Sydney Metro Martin Place

North Tower Base Building Changes

SSD/ MOD drawings & FC2 Comparison

Rev #02 – 26/10/21

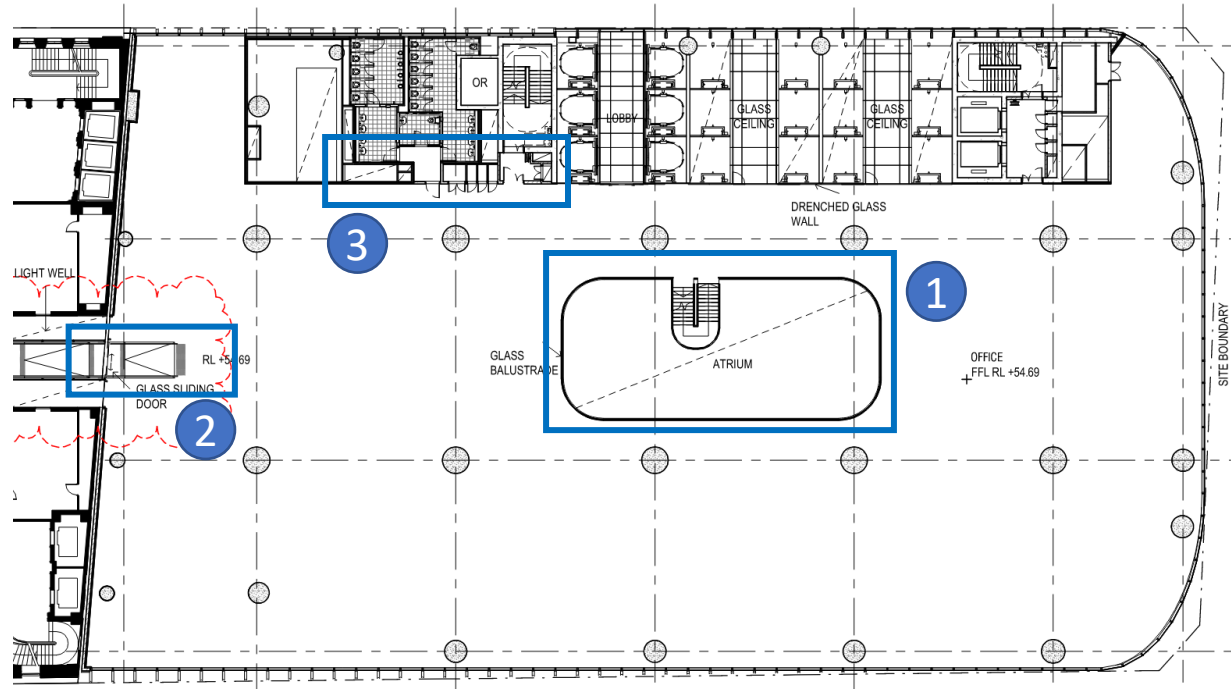
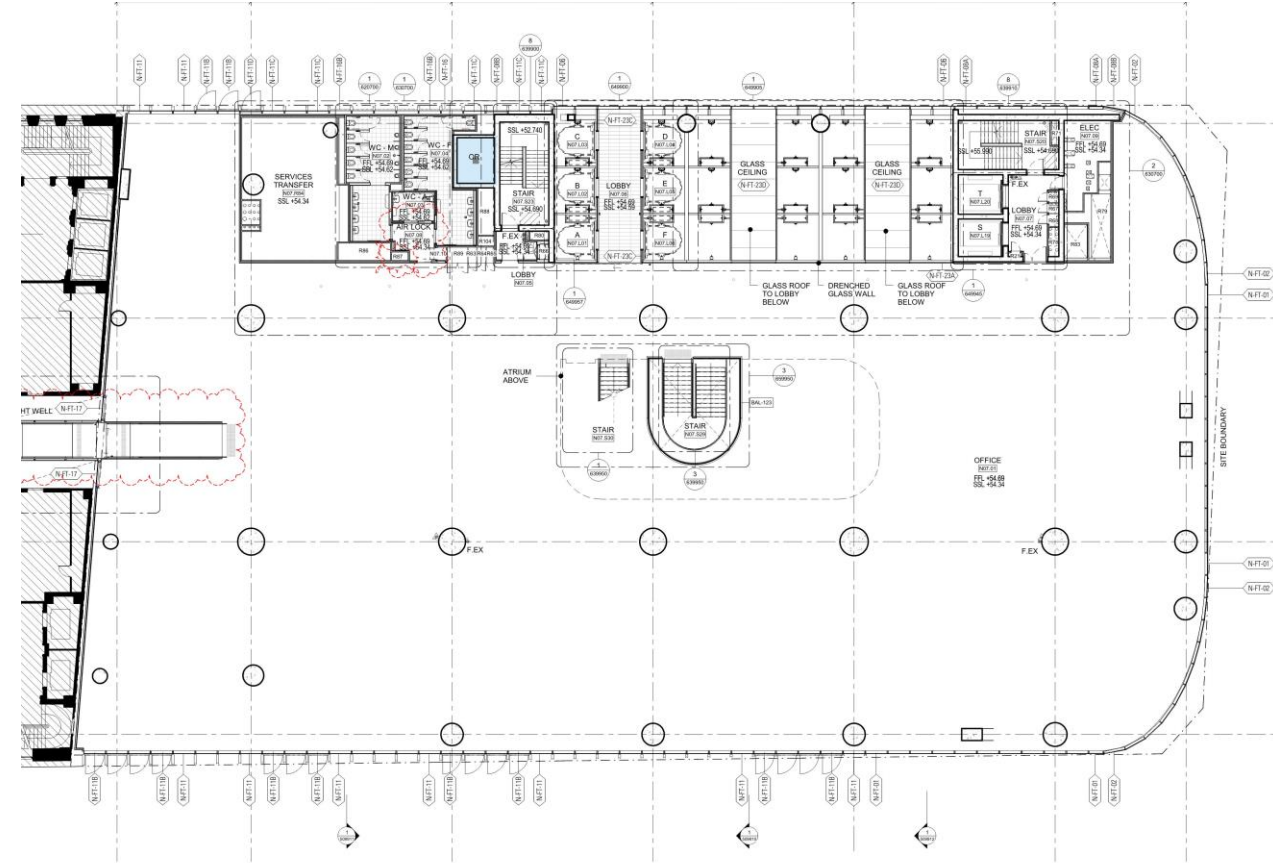
- 1.Stair revised
- 2.Ramp revised
- 3.BOH layout revised

Level 08 Plan

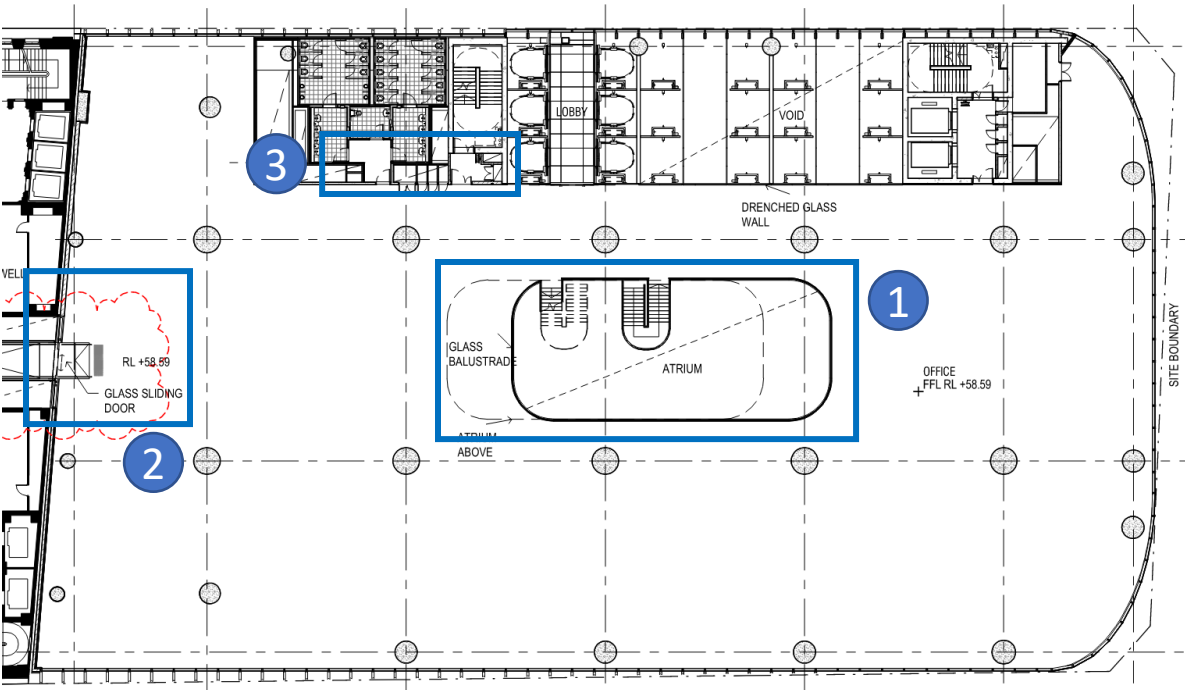
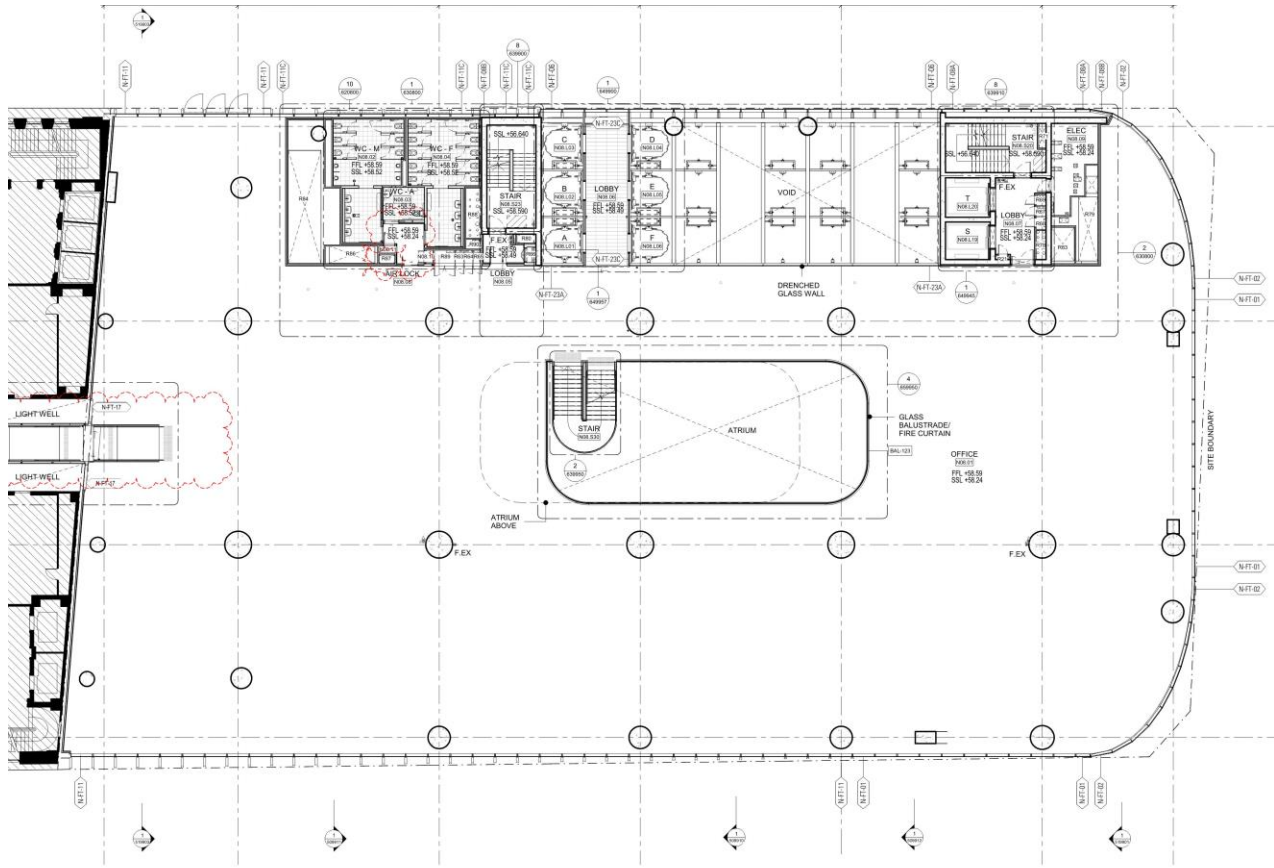
- 1.Stair and atrium revised
- 2.Ramp revised
- 3.BOH layout revised

Level 09 Plan

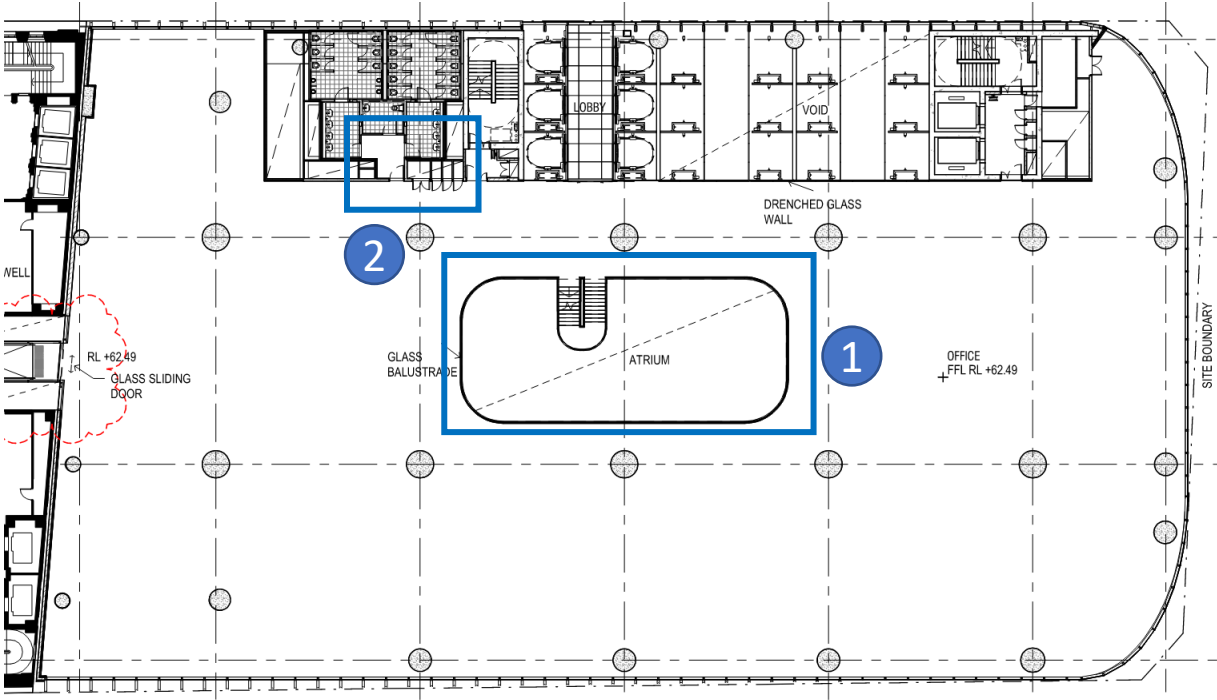
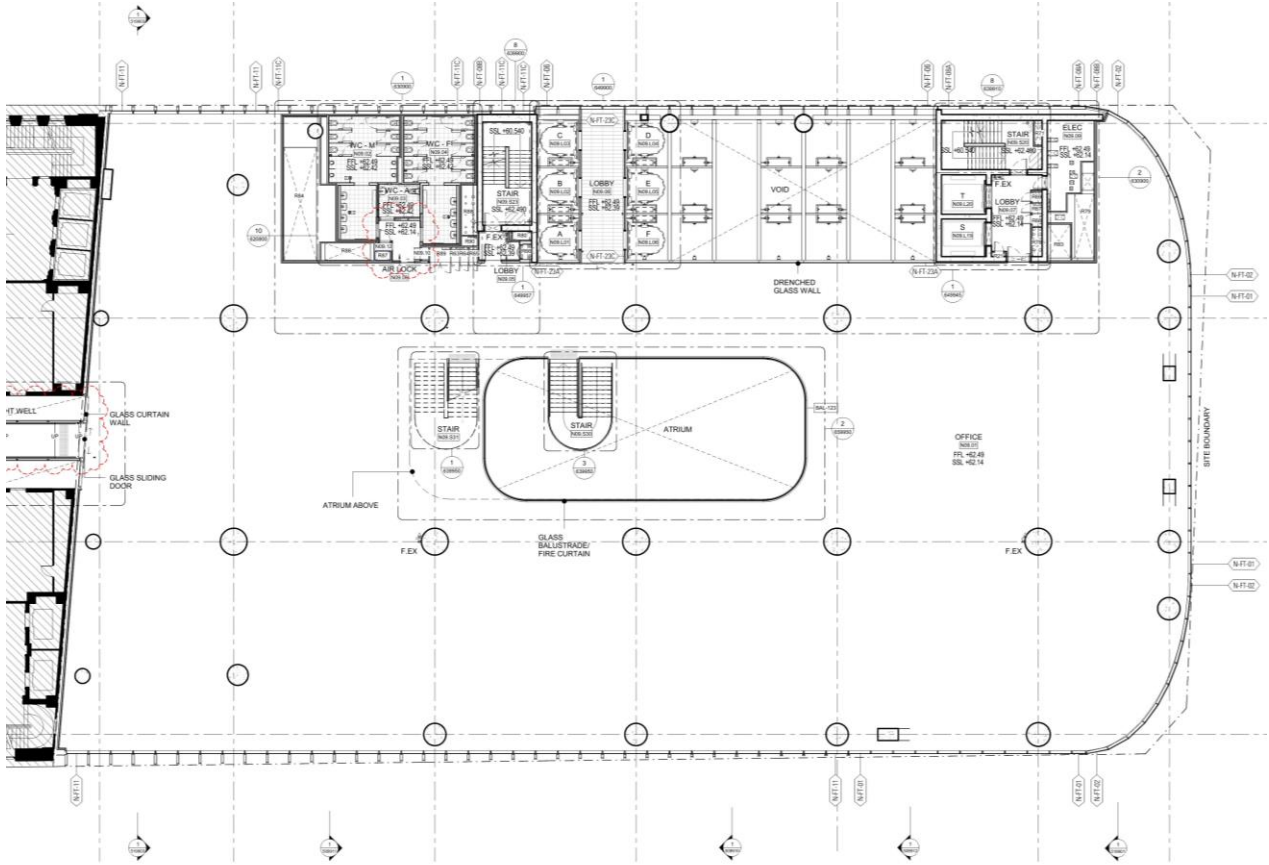
- 1.Stair and atrium revised
- 2.BOH layout revised

Level 10 Plan

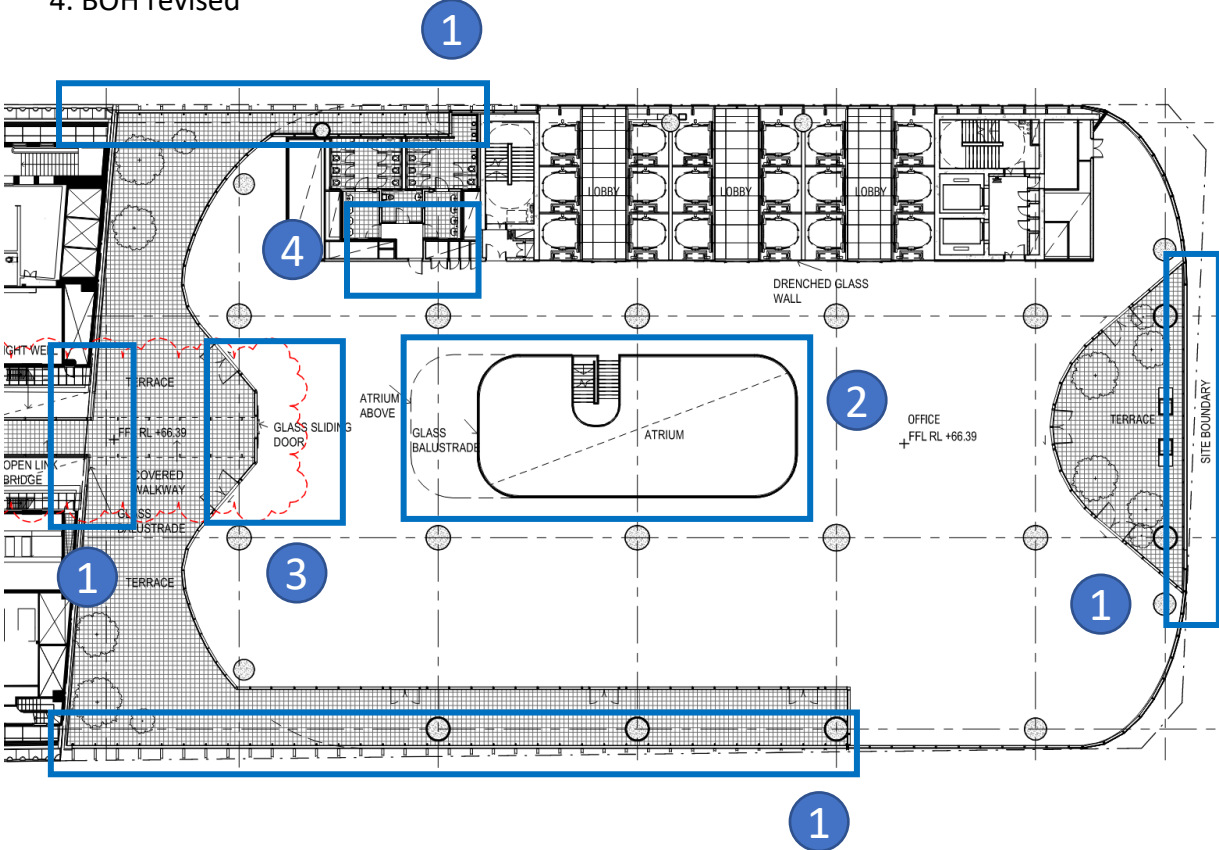
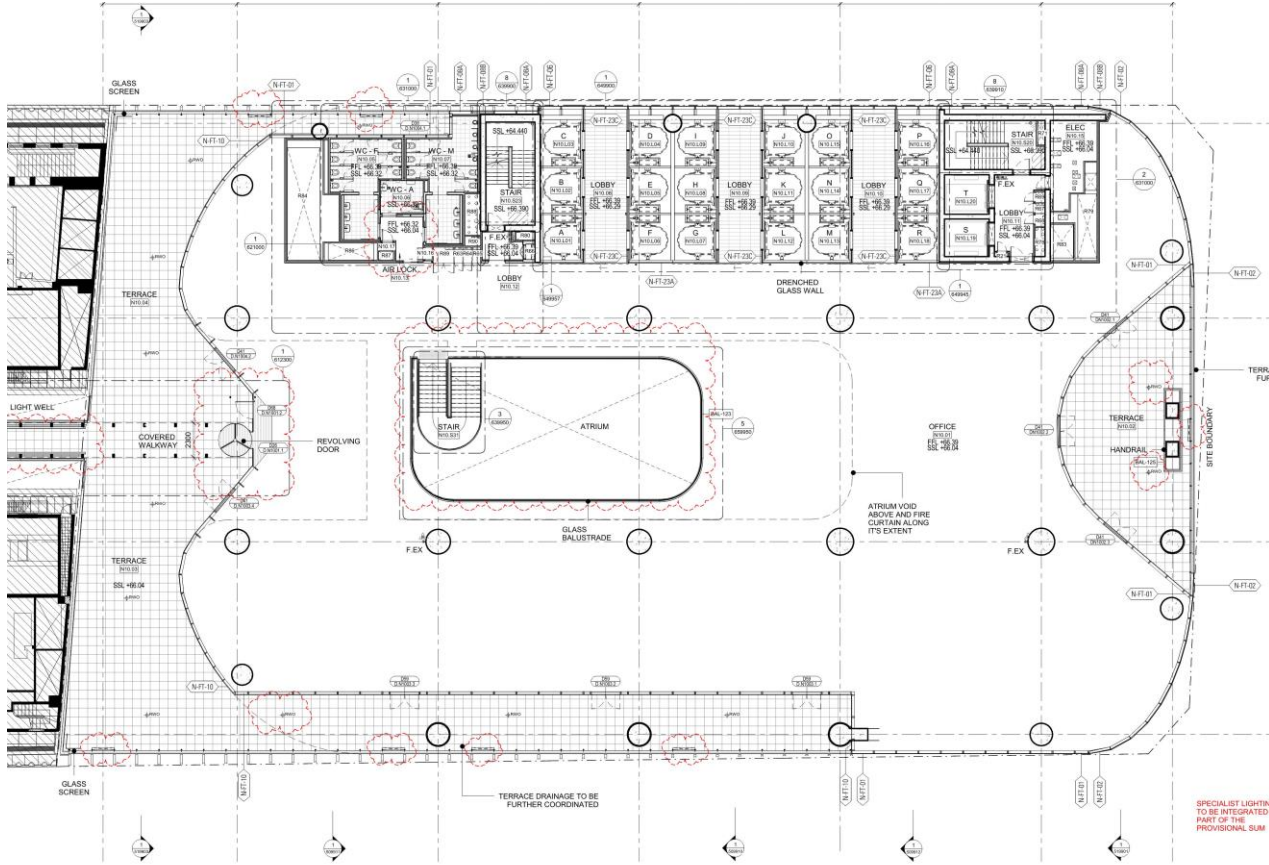
- 1. Balustrade height increased from 1375mm to 1800mm - Change from handrail design to Glazing
- 2. Atrium position changed
- 3. Sliding door replaced by revolving door
- 4. BOH revised

Level 10 External Balustrade Height Increase

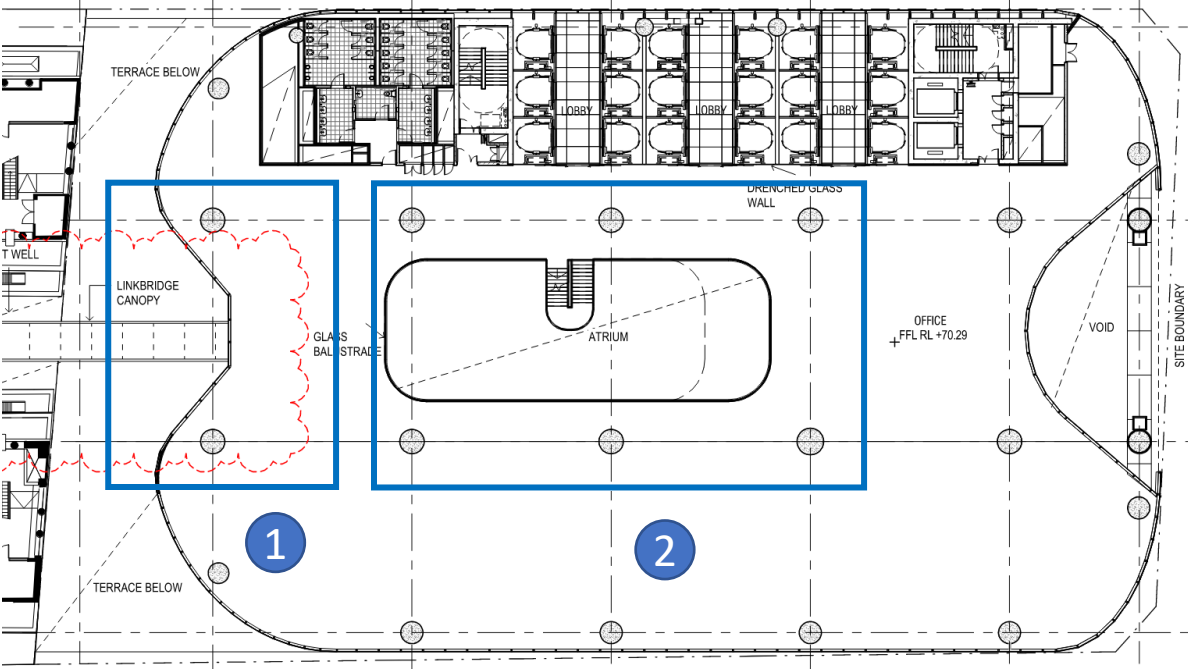
- The external balustrades at Level 10 have increased in height from **1375mm** to **1800mm**
- Because the change is predominantly additional frameless glazing it is unlikely that there would be any visual impact for external receivers.

Level 11 Plan

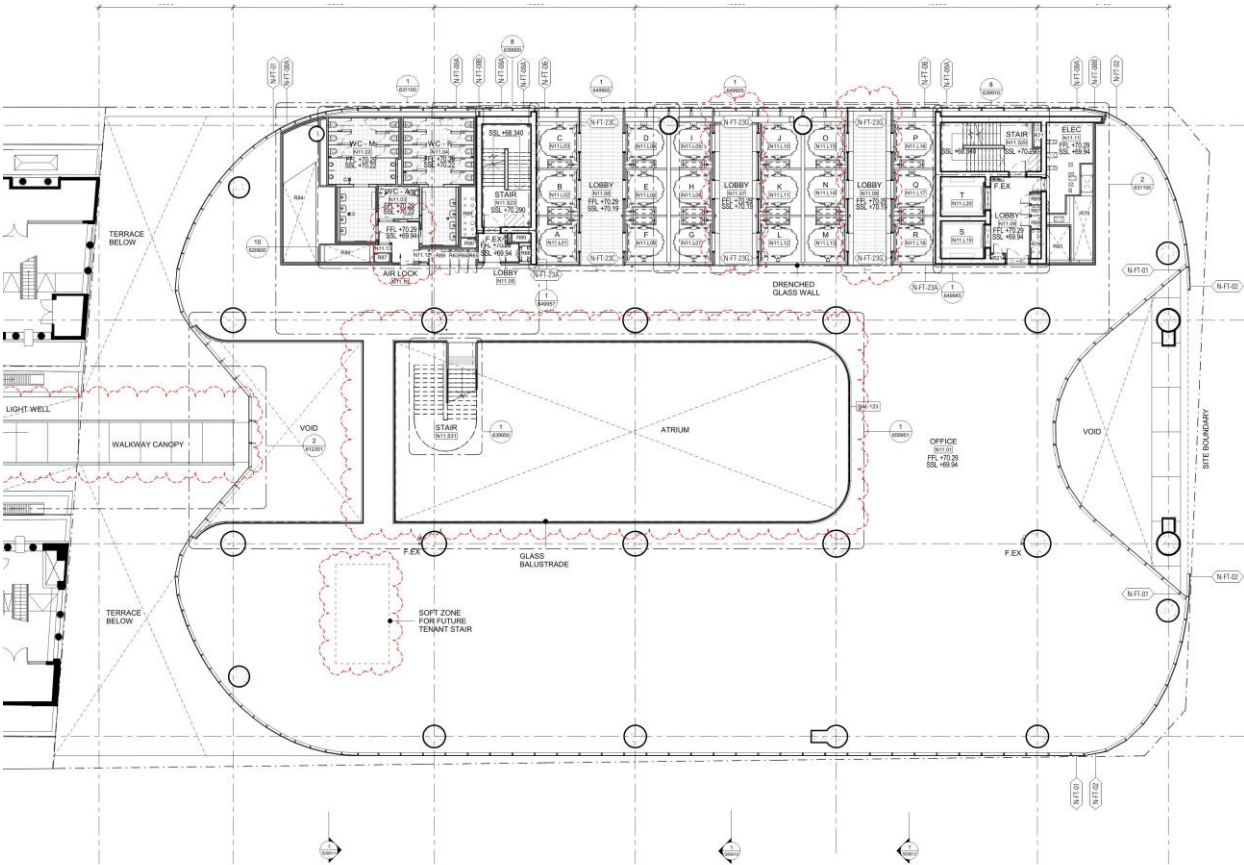
- 1.Internal voids added
- 2.Atrium and stair revised
